## STAR ONLINE PUBLICATION

**Case Number:** S2523000045

**Symptom/Vehicle Issue:** C058E-00 - BRAKE BOOSTER MOTOR "B" POSITION SENSOR CIRCUIT RANGE/PERFORMANCE

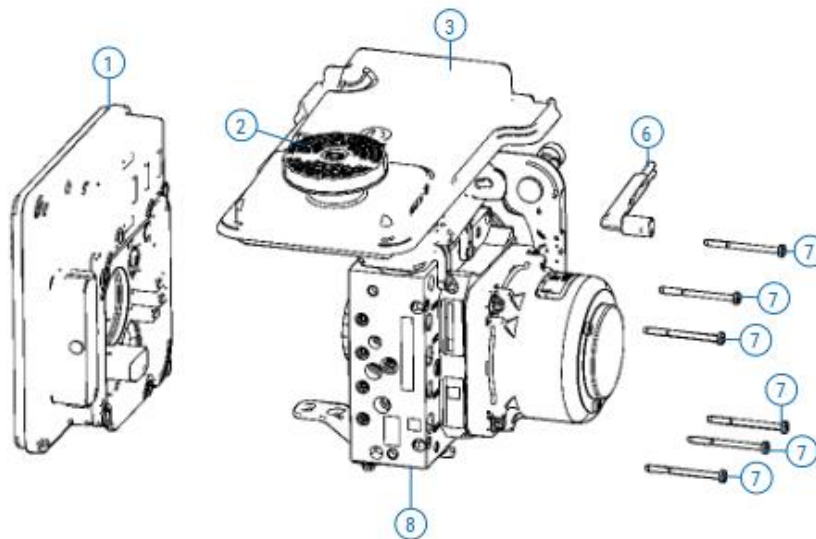
**Discussion:** Service diagnostics have recently been updated for diagnostic trouble code (DTC) C058E-00. When following the DTC diagnostics if the results take you to the final step (step 11) and the answer is “yes”, the DTC did return”, it will be necessary to replace **both** the brake system control module (BSCM) and the electronic brake booster (EBBM). Both parts #1 BSCM and #8 EBBM are shown below.
